Type of manuscript: Article Title: NFV/SDN as an Enabler for Dynamic Placement Method of mmWave Embedded UAV Access Base Stations

Authors: Gia Khanh Tran *, Masanori Ozasa, Jin Nakazato

Reply Letter

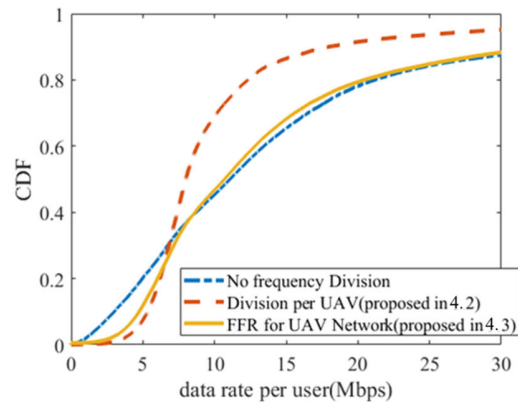
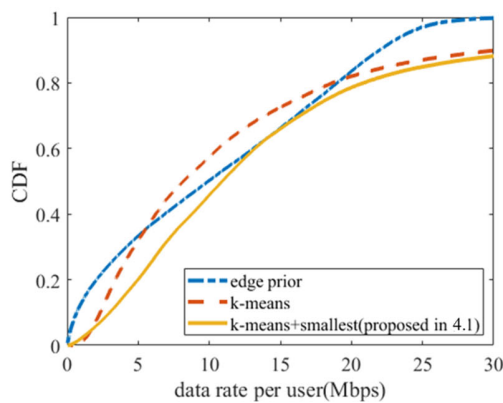
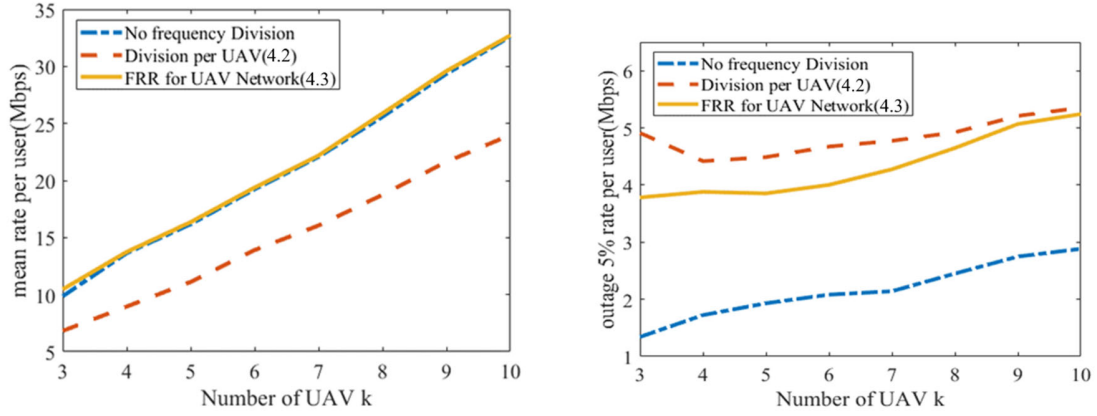
3. *In the paper, the same number is assigned to two figures i.e., 8. It reduced the reader's understanding. Authors should check that all the figures are correctly referenced where the corresponding text is discussed. In many places figure numbers are missing, such as on lines 432, 436, and 457 which creates difficulties in understanding the text properly.*

Please accept our apology for such careless mistakes. After revisiting our editorial process, we found out that such mix-ups of figure numbers were caused by the improper operation of our PDF conversion software. Thanks to your comments, in the revised manuscript, we have checked carefully if all figures had been assigned a unique sequence number and if they are cross-referred correctly together with their explanation texts in the manuscript even after the conversion process. Especially, the issue of missing figure numbers at your indicated locations had also been resolved. Owing to your indication, we also found that there were wrong cross-references inside the legends of our analysis results in Figs. 9-12 and these mistakes are also fixed in the revised manuscript as shown in below figures. Thank you again for the careful check of the manuscript.

Figure 13. Comparison with microwaves⁴

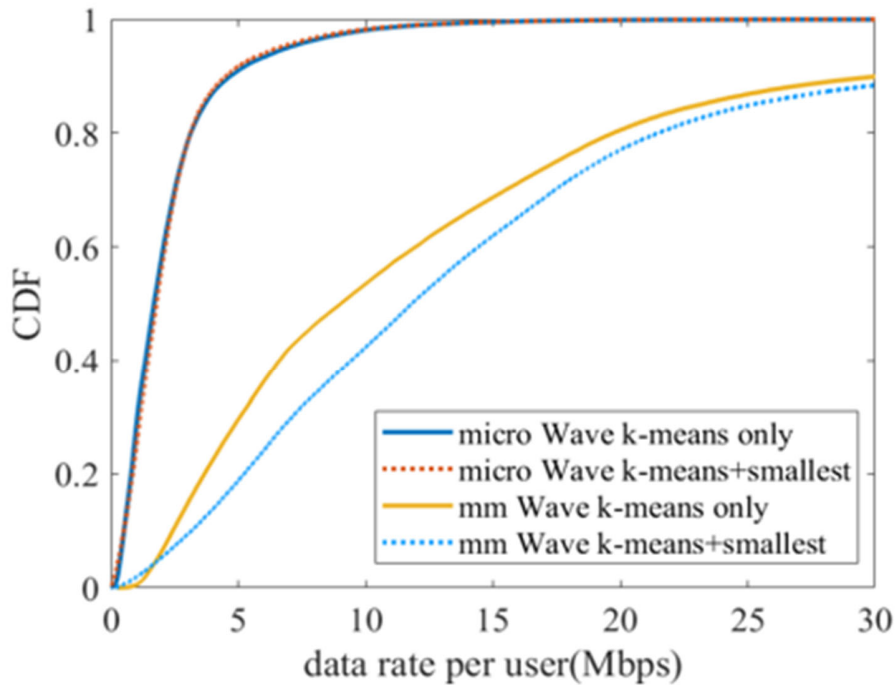
4. It is written that “For this purpose, the four following schemes were investigated and shown in Fig. 13”, however, I have not found Figure 13 in the paper.

Please accept our apology for such careless mistakes. Related to your previous comment, the reason is due to improper operation of our PDF conversion software such that it replaced the original figure number 13 with another one. Owing to your careful comment, all the figures’ numbers had been correctly put and cross-referred properly in the revised manuscript. The corresponding Fig. 13 is therefore redisplayed as follow.
